Date: 6th May 2021
Reference: L2466

Bridge House, Oxford Road, Uxbridge UB8 1HS

BRIDGE HOUSE, UXBRIDGE
GROUND FLOOR DRAINAGE

Status :		CONSTRUCTION	
Scales : As indicated @ A1		Date : Oct 19	
Drawn : KK	Engineer : VM	Checked : M	
Drawing No.		Revision:	
BRH-PRJ-XX-00-DR-C-07000		C

BELOW GROUND DRAINAGE
Scale 1:150

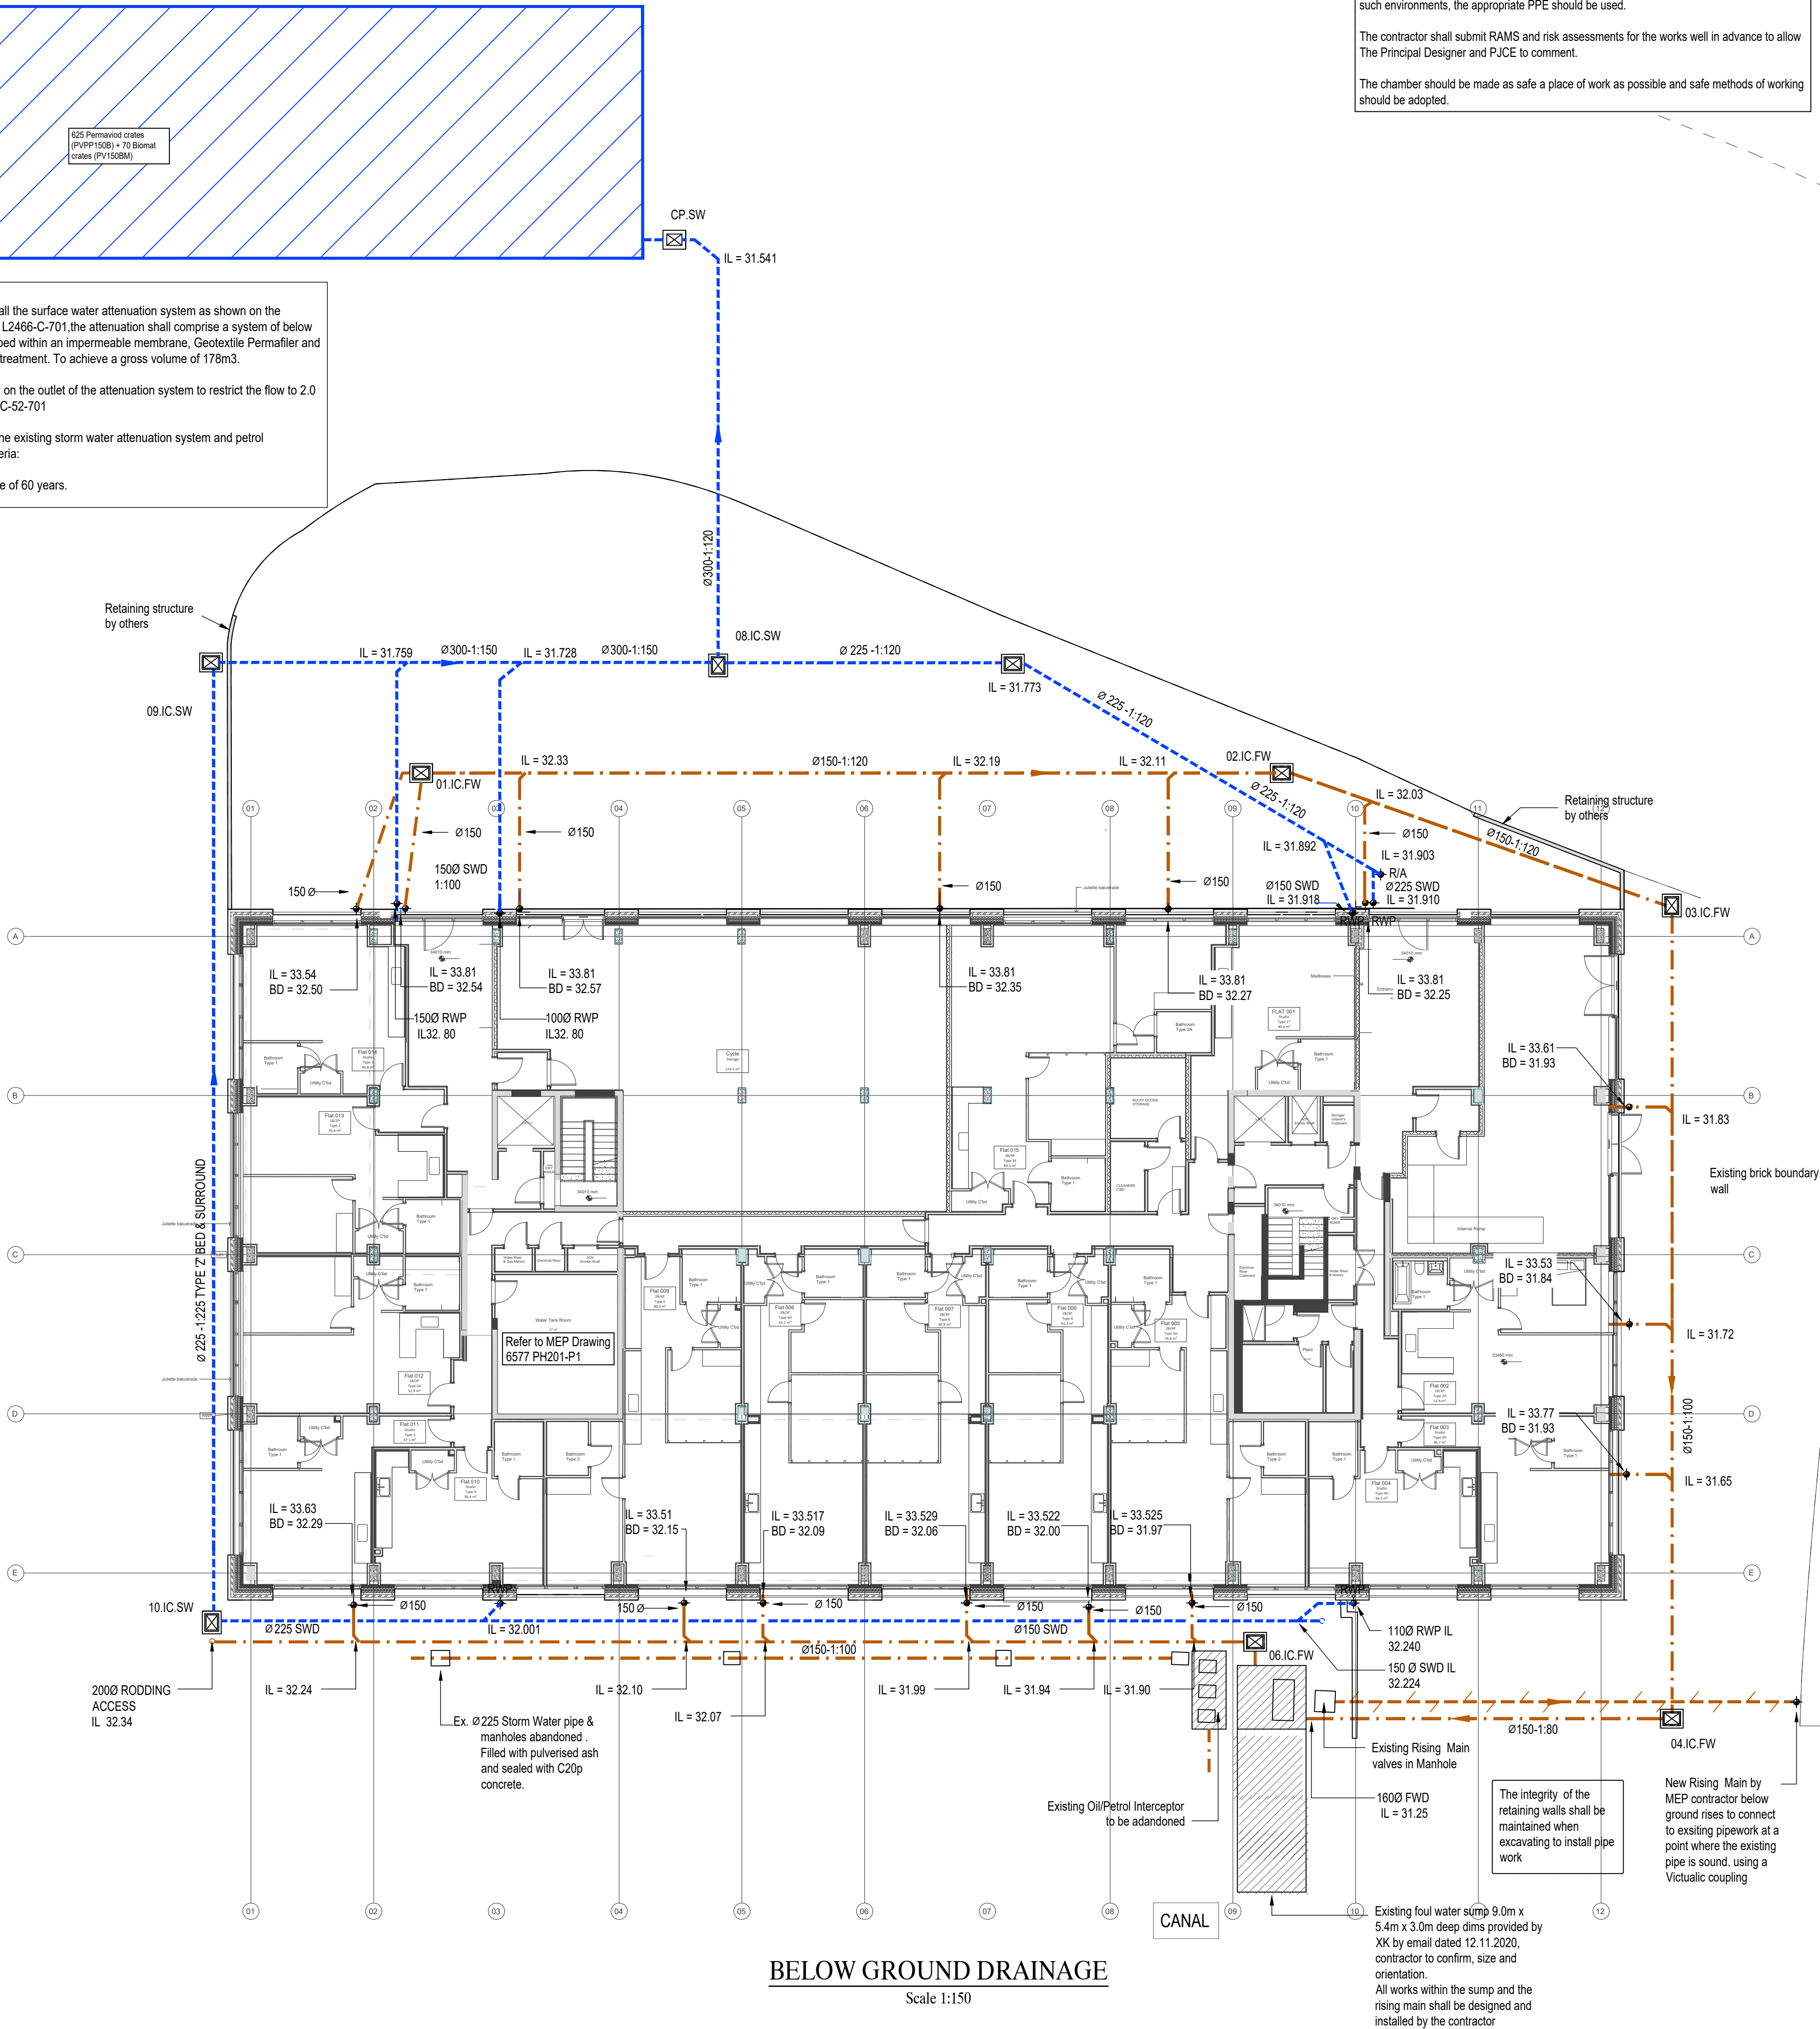
"The Council's Flood and Water Management Officer has reviewed the submitted details and stated that the proposed discharge rates are considered acceptable, however it is not clear that this is the most sustainable design, and that more sustainable options cannot be included. Are you able to provide additional information clarifying this point?"

You requested confirmation that the current drainage proposal complies with the sustainable urban drainage hierarchy. I respond below:

I confirm that the method used to store and control surface water discharge is detailed on PJCE drawing BHR-PRJ-XX-00-DR-C-07000 rev C2. This drawing was embedded in my letter of 26th of April 2021. I attach copy of this letter and an A3 copy of the drawing.

The design includes an attenuation tank with a flow control unit to restrict the flow to 2.0l/s discharge. The attenuation tank has a storage volume of 178m³ and includes a Permavoid biomat, for hydrocarbon treatment.

The green / blue roof was omitted due to structural loading requirements on the building and the attenuation tank was proposed due to the lack of space for a bioretention pond. The bioretention pond would be a superior SuDS solution but cannot be accommodated due to the services traversing the site and electrical substation location. The site is also restricted by the access roadway that services other facilities on the site.

This attenuation tank method of storage facilitates discharge of the surface water to the River Colne and is a suitable method of sustainable urban drainage ie, discharge direct to a surface water body (river).

The proposed surface water discharge is to the River Colne via a 178m³ attenuation with a permavoid biomat. This is detailed on drawing BRH-PRJ-XX-00-DR-C-07000, extract below.

The discharge to other surface water sewers was considered but given the River Colne is immediately adjacent the site, this alternative was considered as lower on the National Planning Practice Guidance details the hierarchy of drainage and rejected.
